Public Works Standard Drawings Subcommittee Meeting

Monday, April 13, 2020 WebEx

Division 2000: Pavement Systems

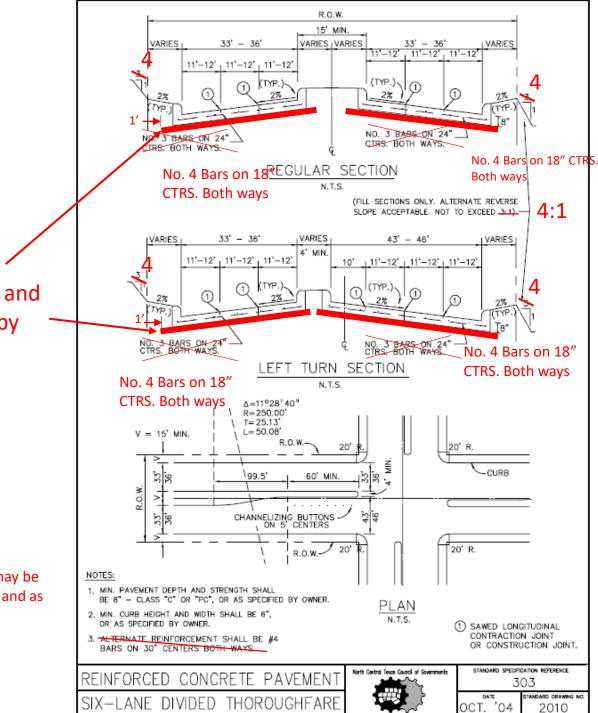
Replace Plan with a more general layout to include crosswalks, ADA ramps, striping, and possibly additional lane width for bicycle lanes per TxDOT 8" minimum stabilized subgrade per section 301 and as approved or specified by owner

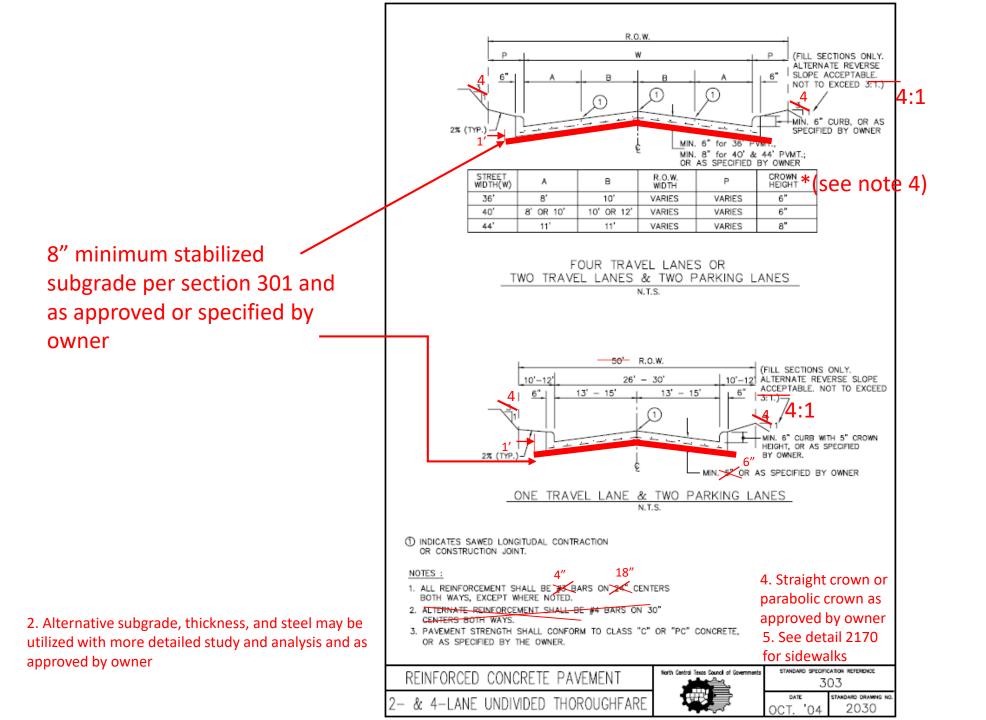
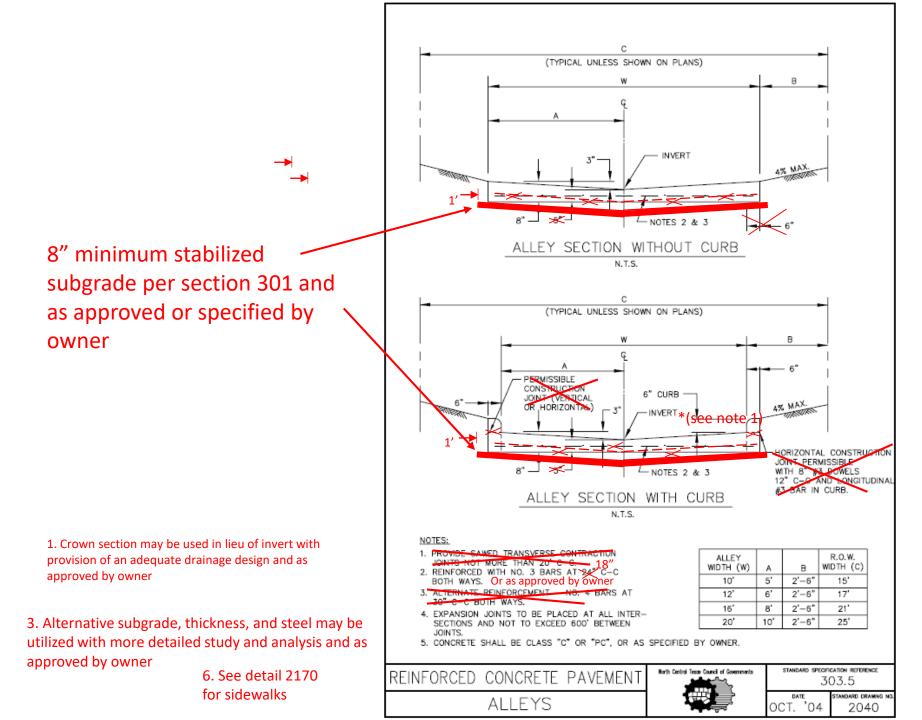
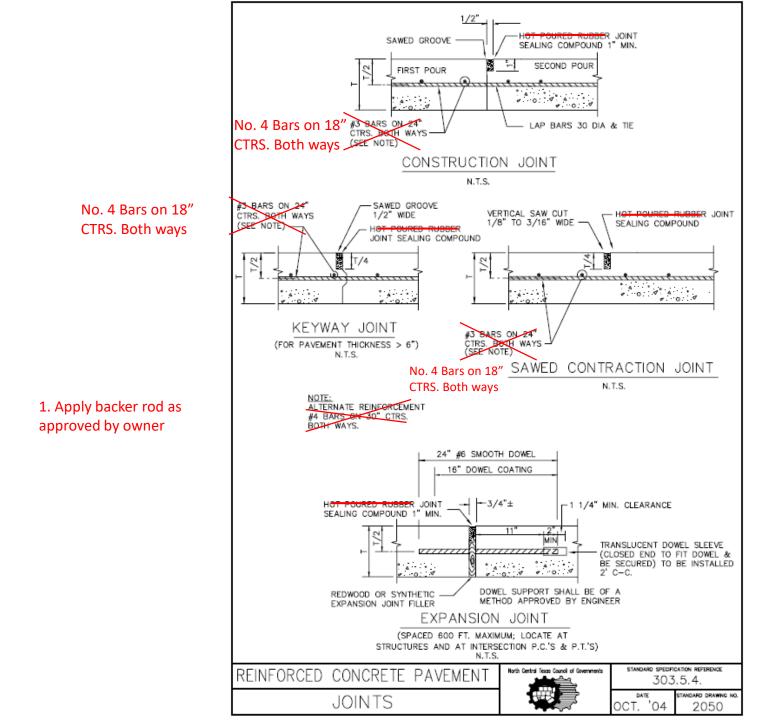
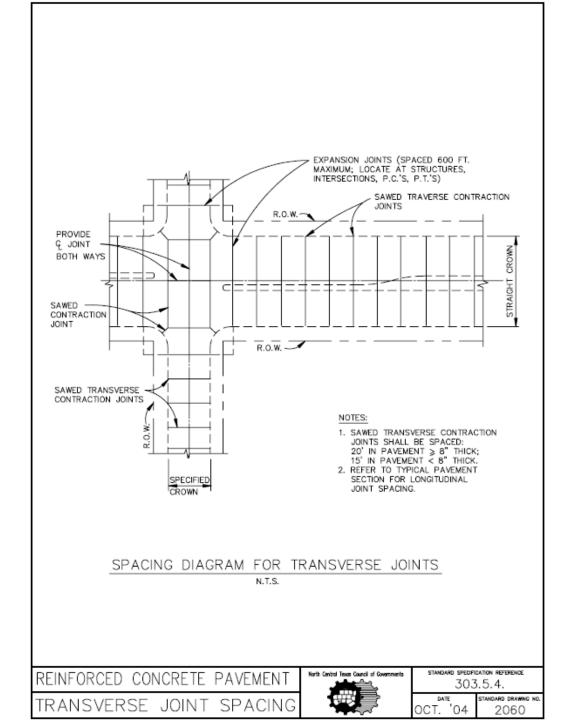
Replace Plan with a more general layout to include crosswalks, ADA ramps, striping, and possibly additional lane width for bicycle lanes per TxDOT

*cleanup lines through median

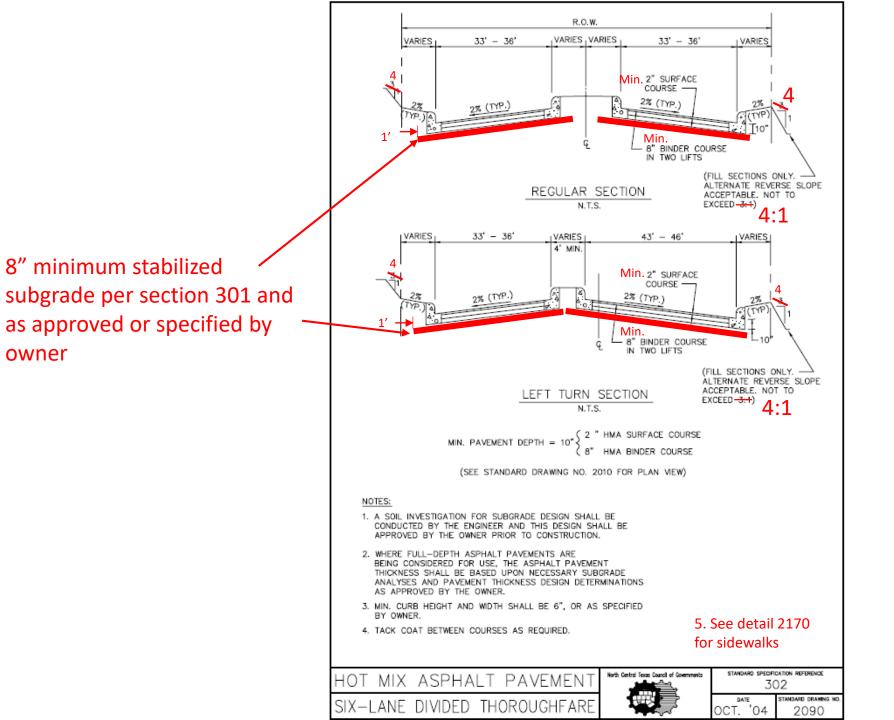
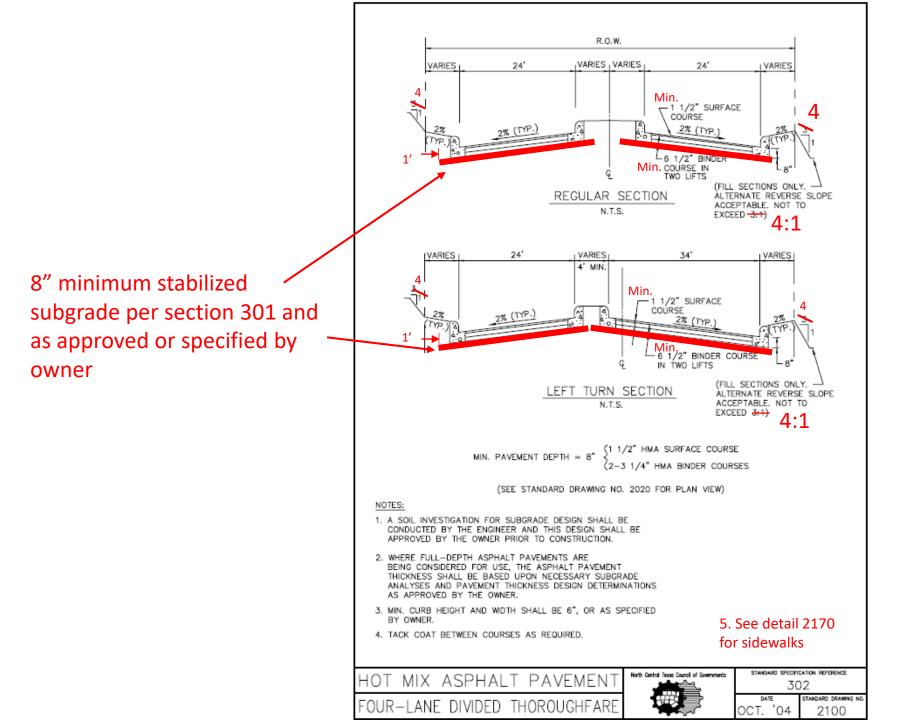
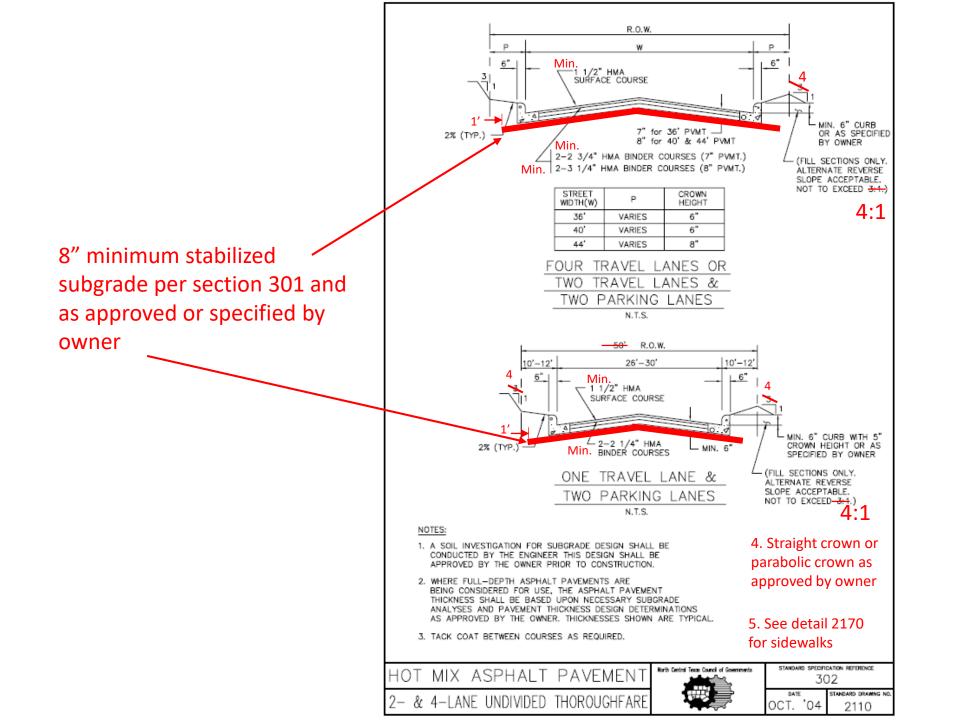
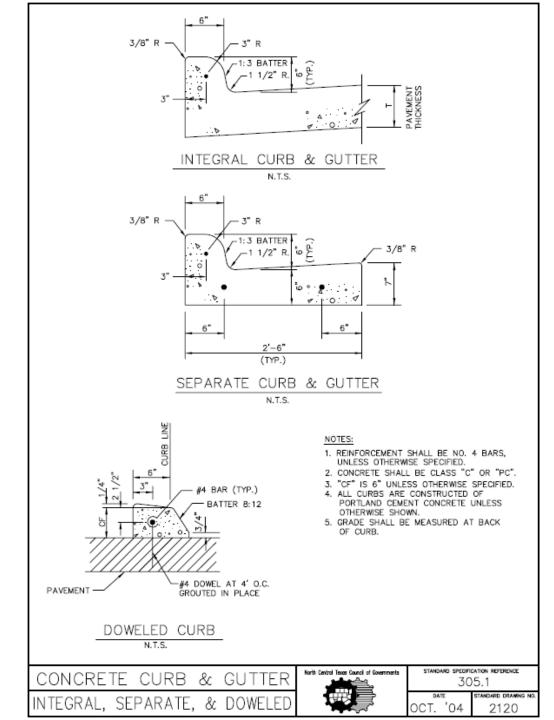
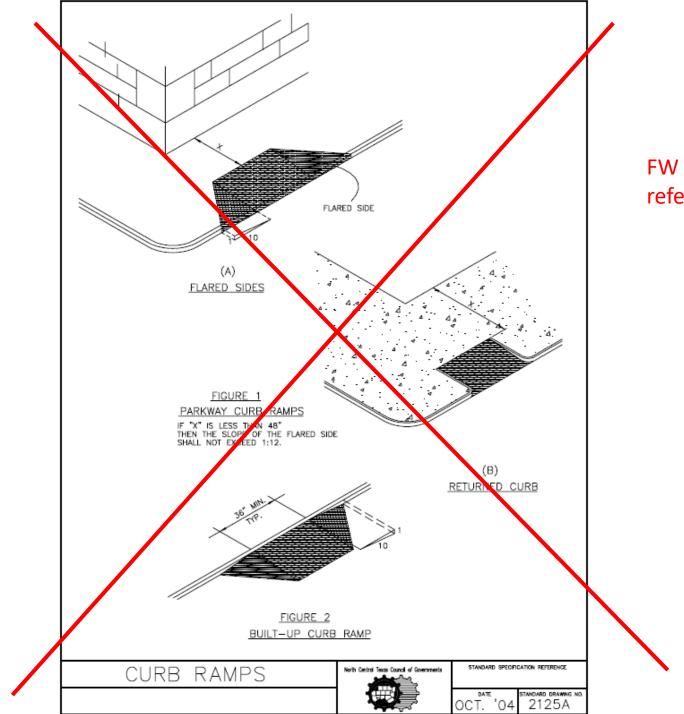
Remove detail and reference TxDoT detail in specs if needed

FW examples or reference TxDot

2125B

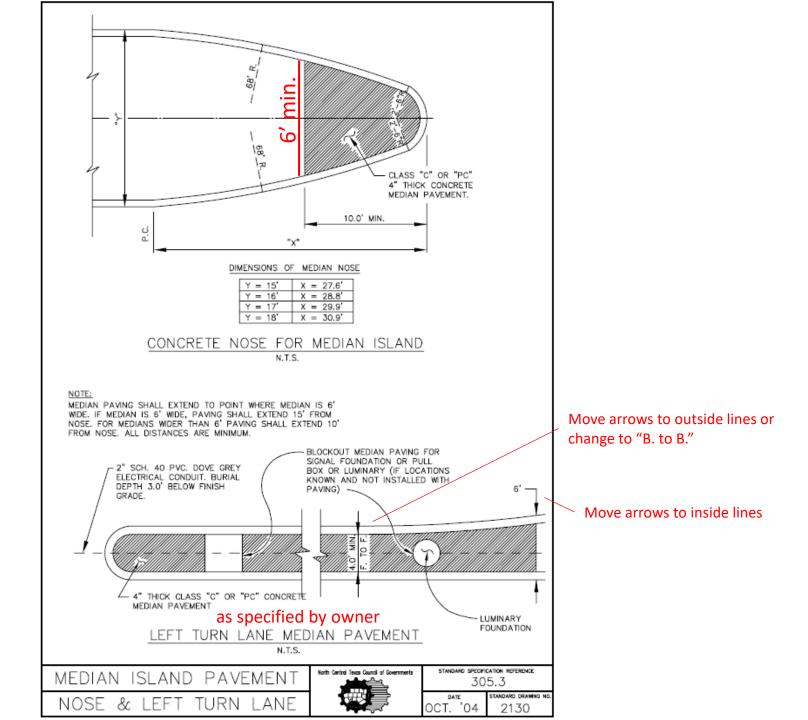
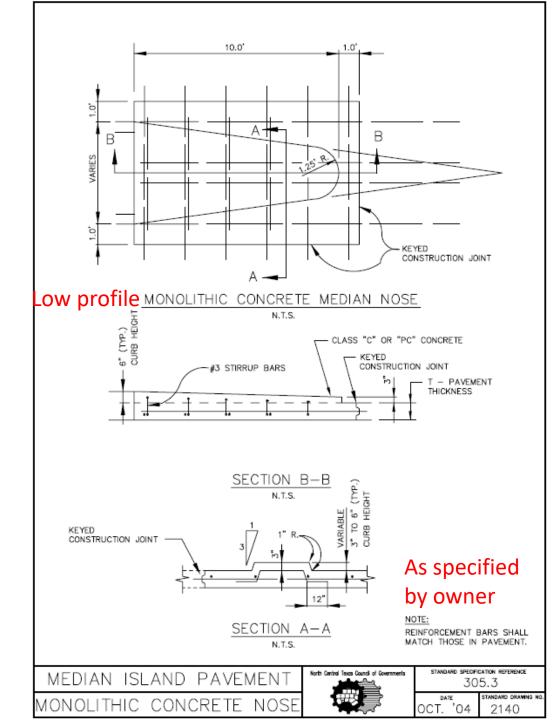
Update and remove 2125A or update to reference other detail
